Near-Infrared Tip-Tilt Sensor System Design Review

December 7, 2010

Reviewer Topics

2c) Review alternatives of NIR TTS location on AO bench

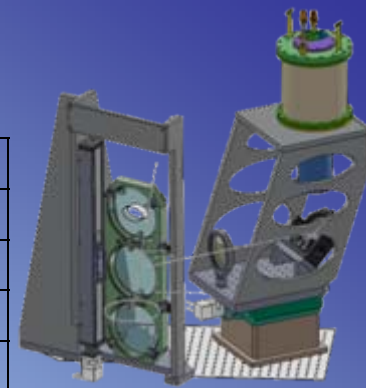
- Proposed location is small & difficult to access
- Not demonstrated that the proposed design fits the envelope
- Not clear if alternatives have been considered, for example can the pupil simulator be moved or redesigned to provide more room?

- A location between the IR transmissive dichroic & OSIRIS is strongly preferred. System size depends on proximity to focus.
- This is the only viable location we could identify. The current design does fit into this location (tightly), including some extension off the AO bench.
- We did include modifications to the pupil simulator in the proposal budget, but our current design does not seem to require this.
- An updated SolidWorks model fully consistent with the design & existing bench will be produced for PDR.

2b) Reconsider design to better use NIR TTS as a NGAO pathfinder

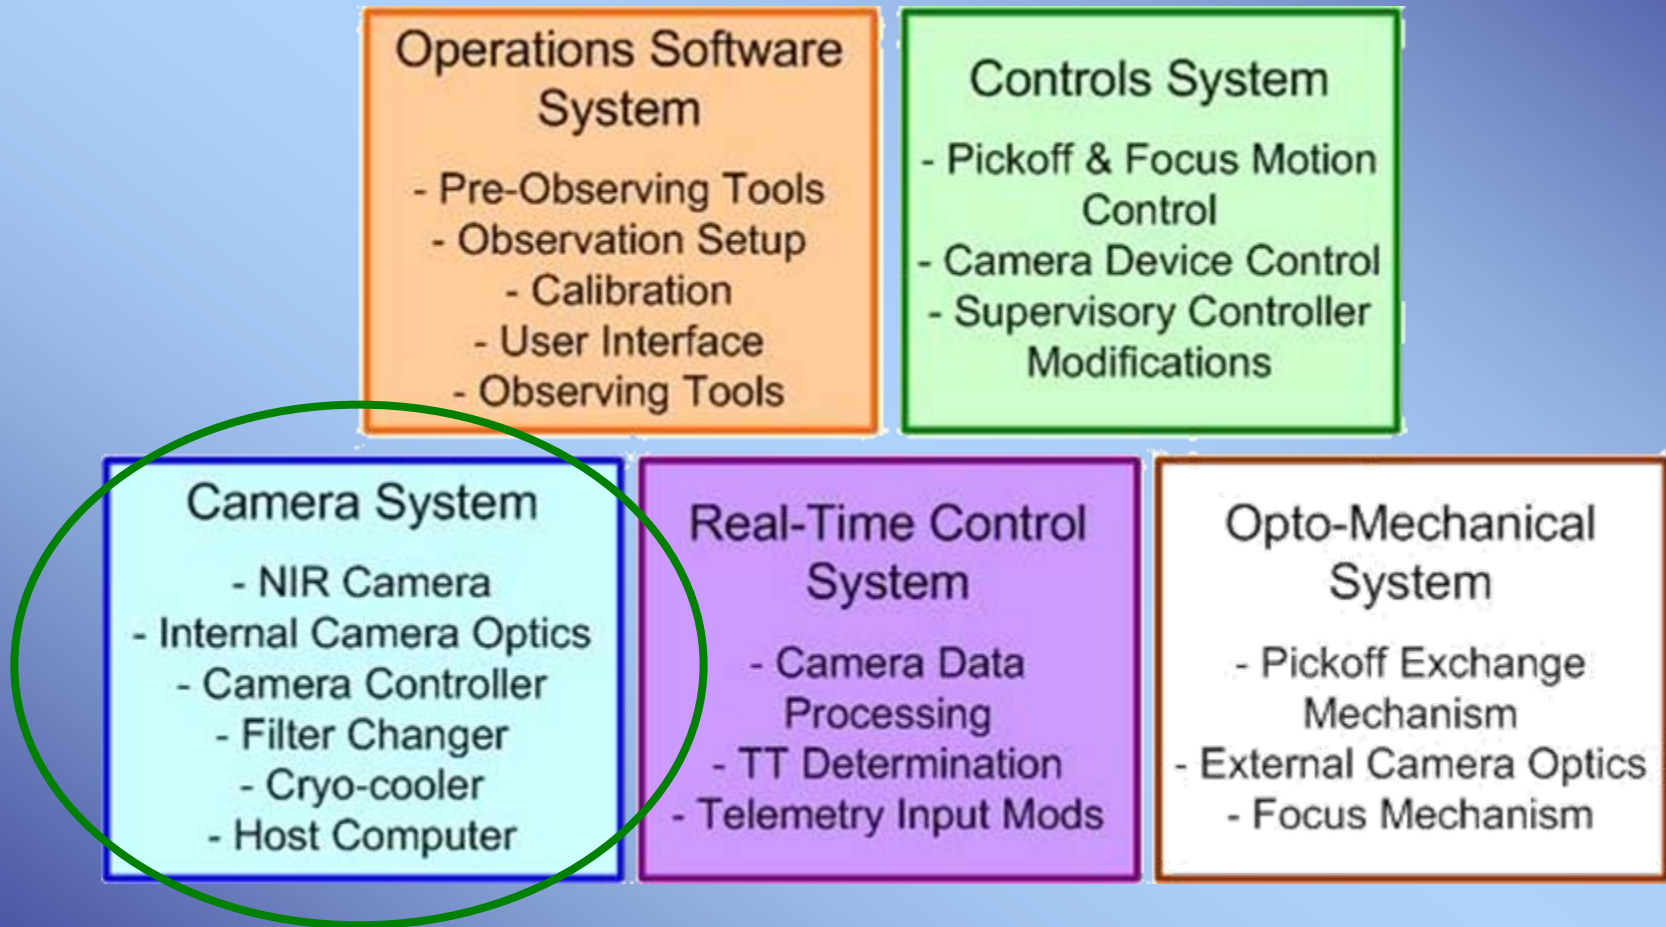
- In particular review possibility to include TT mirror &/or MEMS

Response: We did consider this extensively during the SD.

- Proposed an [AO-corrected NIR TTS upgrade](#) for \$2.6M of TSIP funding (not approved by SSC). In addition to MEMS requires a 2nd movable laser beacon & WFS, & mods to RTC, controls & observing SW.

- We did consider a TT mirror but rejected this for cost & complexity reasons.
 - Cold TT mirror in a tight space or a 2nd pupil location required.
- Breaking news: the current fold mirror could provide benefits as an affordable TT mirror option. Will pursue in PD.

- The pupil shift is 0.9% per arcsec of tilt.
 - The effect on image quality is negligible for 1" & only changes the ensquared energy by a few % for shifts up to 2".

- DAR is only 16 mas between science at J & TT sensing at K for a zenith angle change from 45° to 50° (~20 min exposure).
 - Could offer focus benefit by allowing us to keep 1 TT star at 4 pixel intersection.

- Current design offers multiple benefits to NGAO: Tests LOWFS dewar, demos use of 1 & 3 NIR TT stars, tests TT performance benefits, able to check focus benefit, + overall controls & operations.

2a) Detector plate scale & algorithm

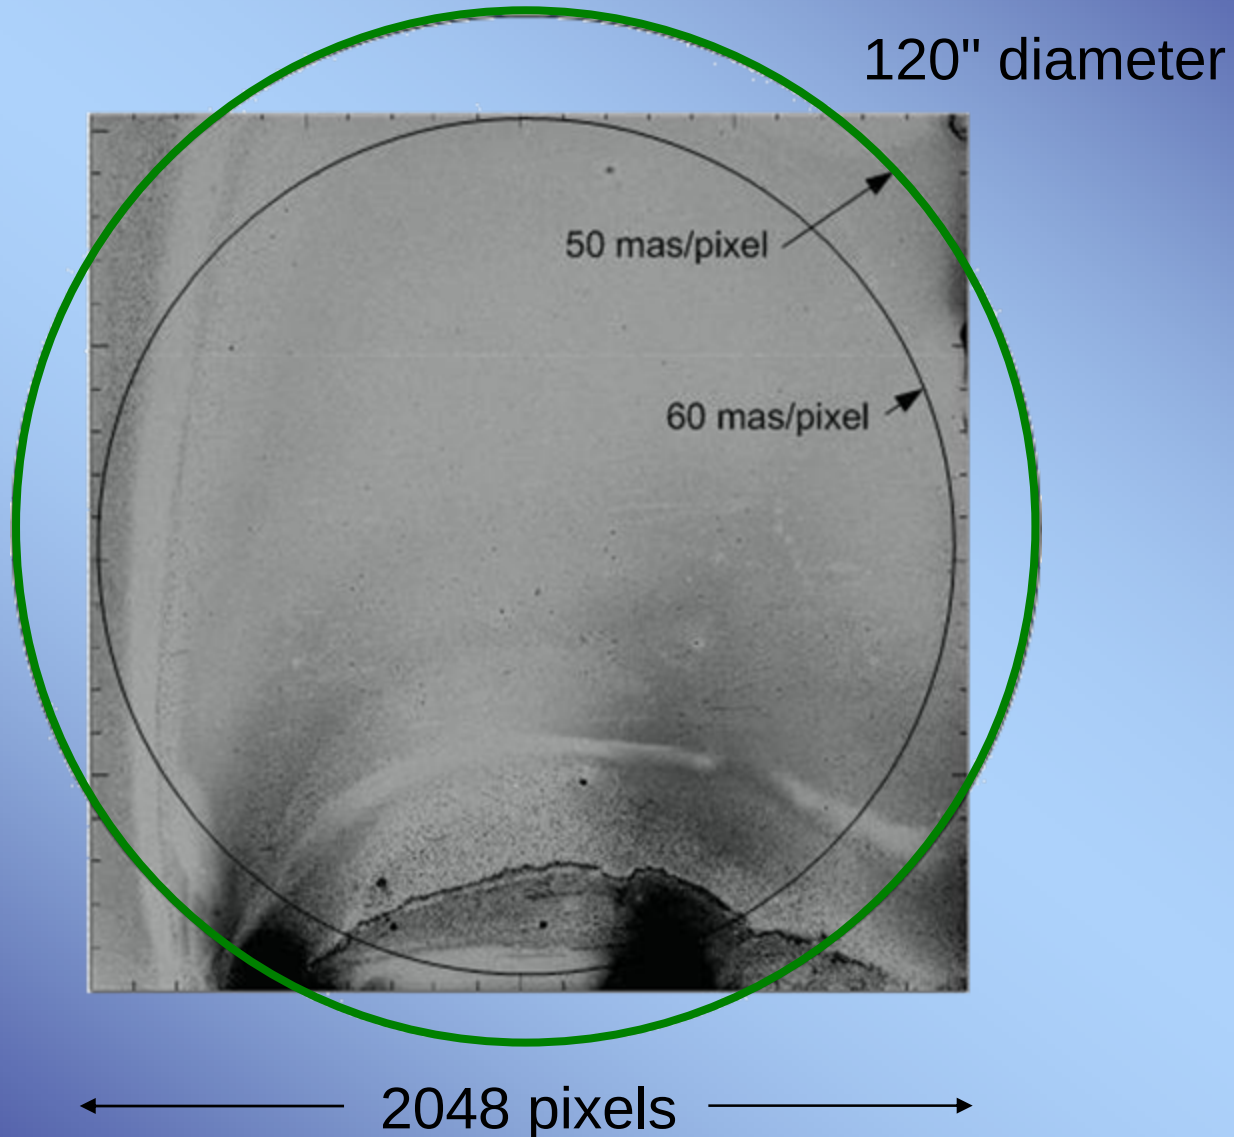
- Additional simulations to confirm the choice of plate scale & algorithm during PD
- How to estimate centroids gain when using multiple guide stars?
- How correlation algorithm works with changing ROIs?

- Additional simulations will be performed during PD.
- Current baseline approach is to use Strehl to estimate centroid gain for each guide star. Get Strehl from signal in 2x2 pixels divided by total flux from acquisition image.
- Unclear why correlation algorithm would have a problem with changing ROIs. Could use a larger correlation region if necessary not to have to move the ROI at the expense of noise.

2d) LBWFS

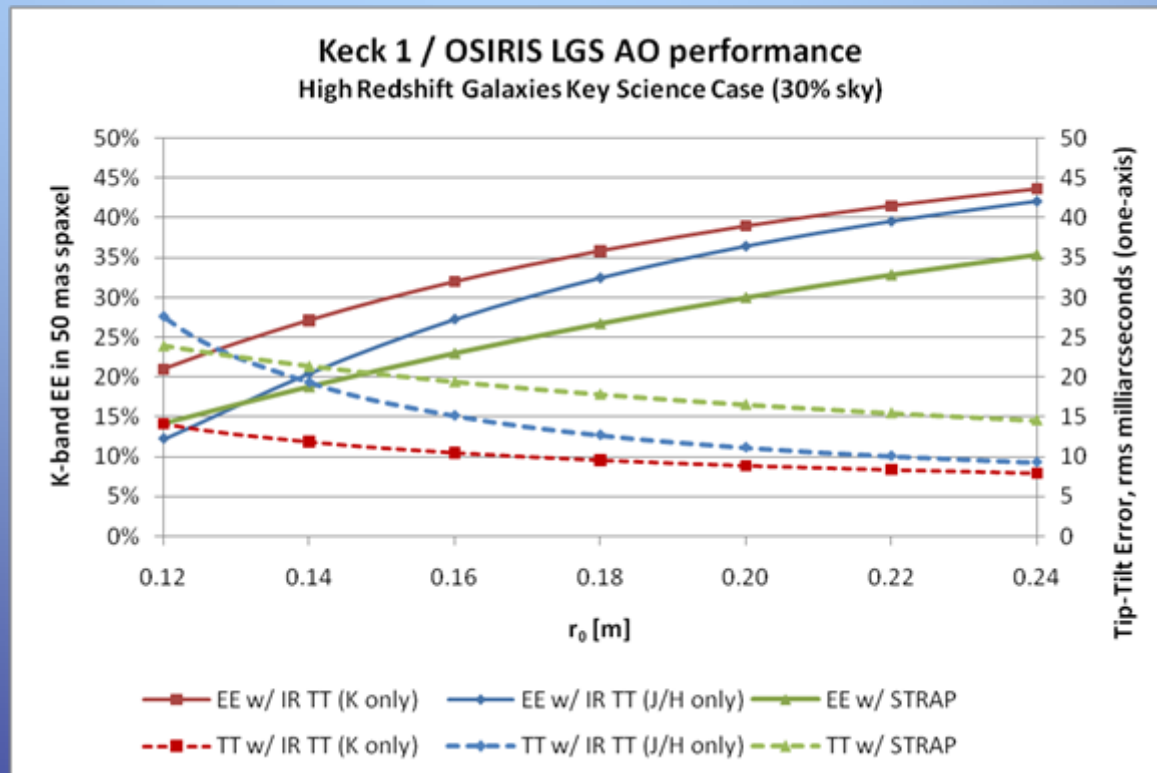
- Proposed system does not solve the sky coverage limitations with the LBWFS. Consider solutions to increase sky coverage for this system such as sending all the light to the LBWFS (requires an additional mechanism). May still be an issue in dust obscured regions.

- NIR TTS performance model has LBWFS (Truth) WFS in error budget spreadsheet with assumptions consistent with 5x5 mode of current LBWFS
- Same tool/assumption used for NIR TTS sky coverage calculations
- Center launch reduces need to measure centroid offsets (mostly Na focus & Na profile (spherical ab.) changes; elongation effects greatly reduced)
- LBWFS must integrate long enough to average atmospheric effects including off-axis anisoplanatism
- In dust obscured regions probably have to take performance penalty
 - For dust obscured regions like the GC can use the currently used NGS for the LBWFS while using IRS-7 for H-band TT sensing.
 - If necessary, could move to nearby visible band star, update LBWFS measurement, leave fixed for integrations, & return to visible star periodically
